RE: 78737 Central Ave NW Grading and Drainage Plan Engineer's Stamp Date: 01/18/23

Hydrology File: K09D053

DRAINAGE AND TRANSPORTATION INFORMATION SHEET (REV 6/2018)

SERRANO, DANIEL (M. TRUJILLO, ARCH) - GRADING & DRAINAGE PLAN

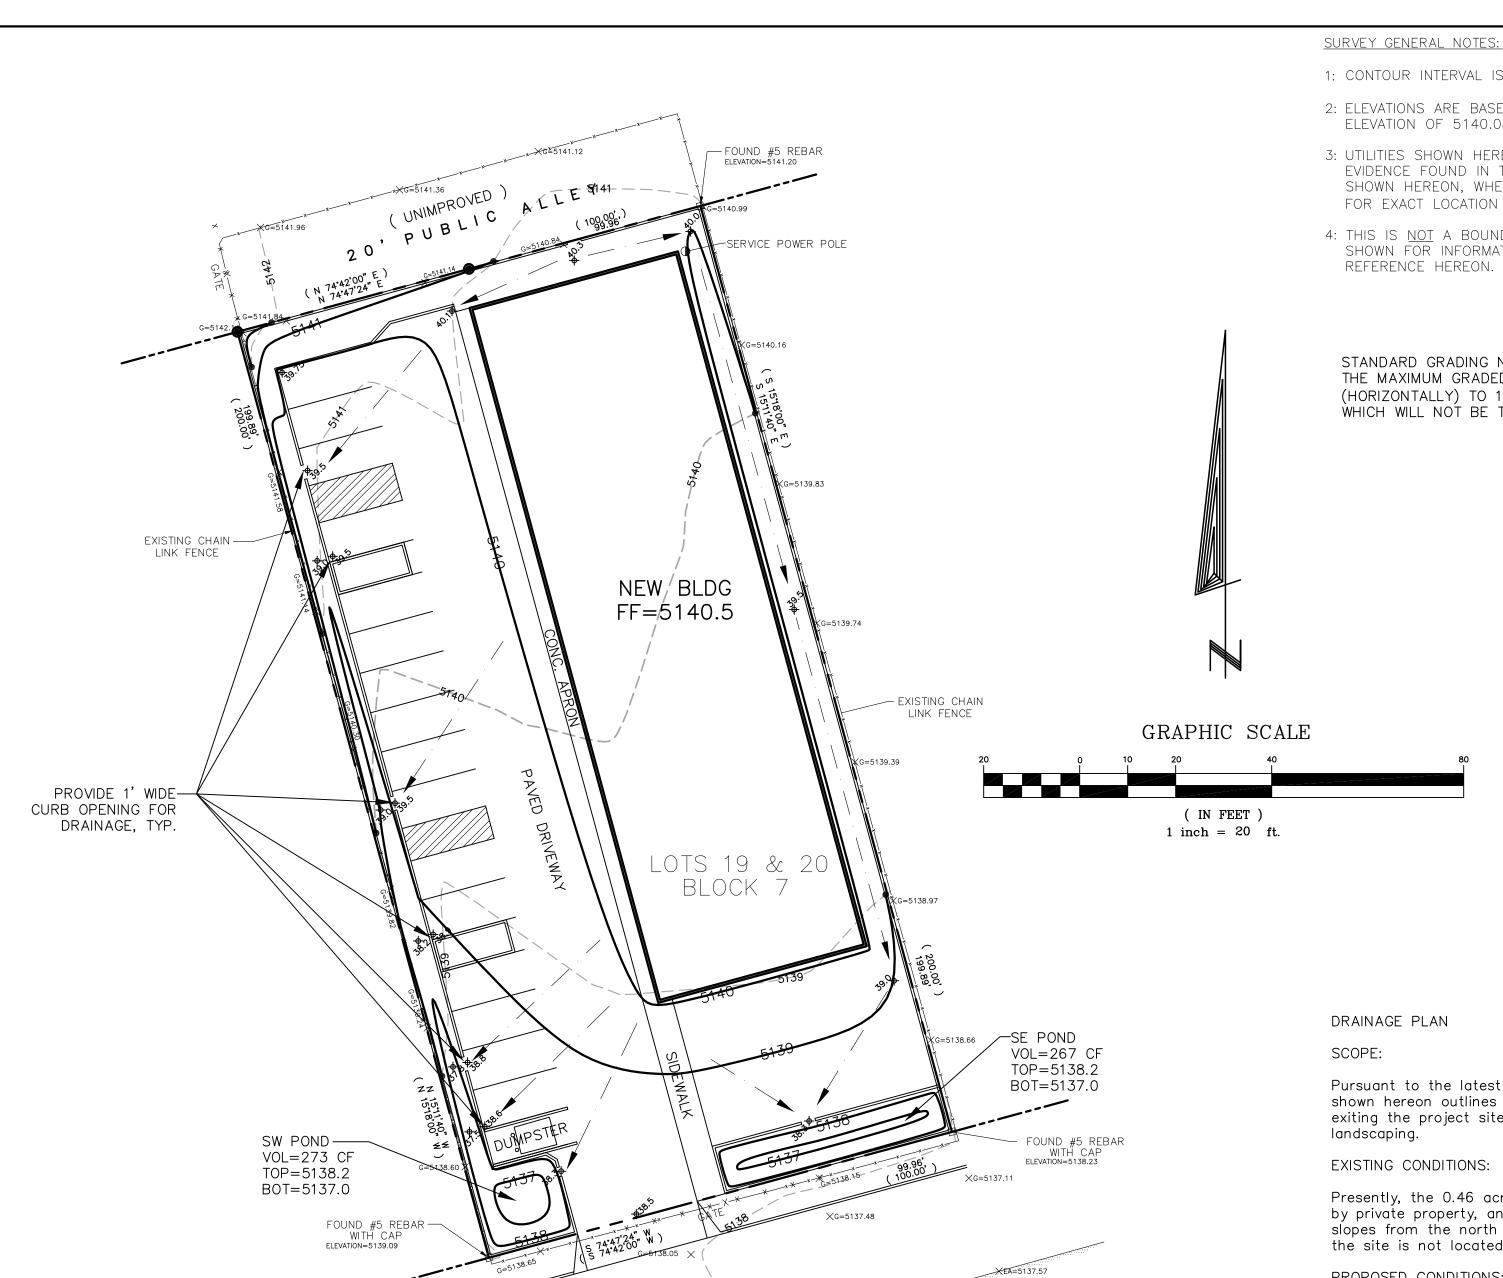
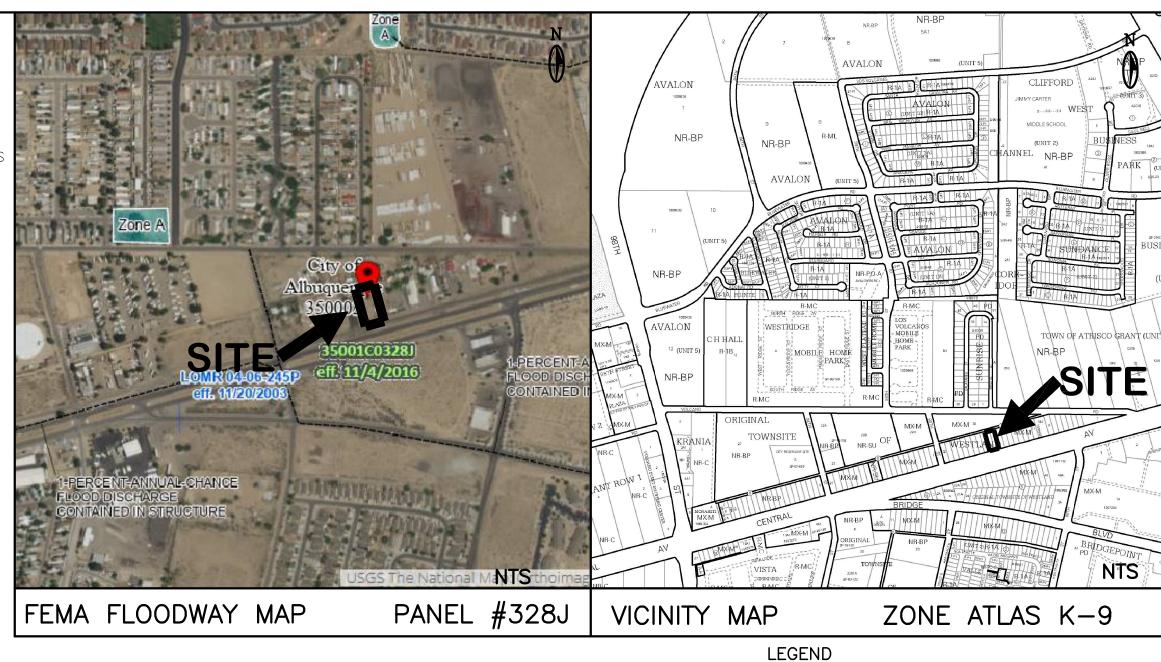
Based upon the information provided in your submittal received 10/25/2022, the Grading & Drainage Plan is approved for Building Permit and Grading Permit. Please attach a copy of this approved plan in the construction sets for Building Permit processing along with a copy of this letter.

1. Engineer's Certification, per the DPM Part 6-14 (F): *Engineer's Certification Checklist For Non-Subdivision* is required.

2. Please provide the executed paper Drainage Covenant (latest revision) printed on one-side only with Exhibit A and a check for \$25.00 made out to "Bernalillo County" for the stormwater quality ponds per Article 6-15(C) of the DPM to Hydrology for review at Plaza de Sol.
